IMPORTANT PRODUCT INFORMATION

Product: IC693DSM302 Module (“DSM302”)
IC693DSM302AD
Firmware Version 1.30

Enhanced Follower Axis Ramp Control

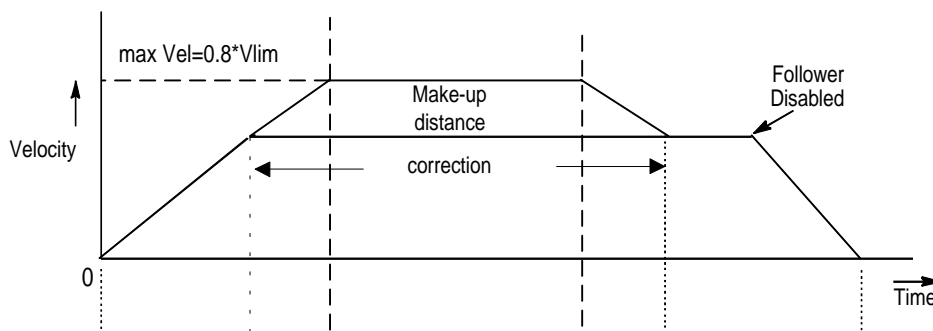
The Follower Axis Ramp Control Function is enhanced in DSM firmware release 1.30. The enhancement improves motion smoothness. Prior to this release, when the follower was active and the master in motion, the acceleration/deceleration control during the make-up correction phase was not controlled by a velocity profile. This could cause unwanted machine shock. The enhanced method uses a trapezoidal velocity profile to address this problem. During the entire make-up correction phase, the acceleration/deceleration is limited to the jog acceleration value. Also during the correction, the velocity is not allowed to exceed the maximum. Appropriate warning/error codes notify the user about abnormal operation (see error table below).

The figure below shows the velocity profile during the follower ramp cycle. *Note: The enhanced follower make-up may affect existing applications that use the old follower make-up feature.*
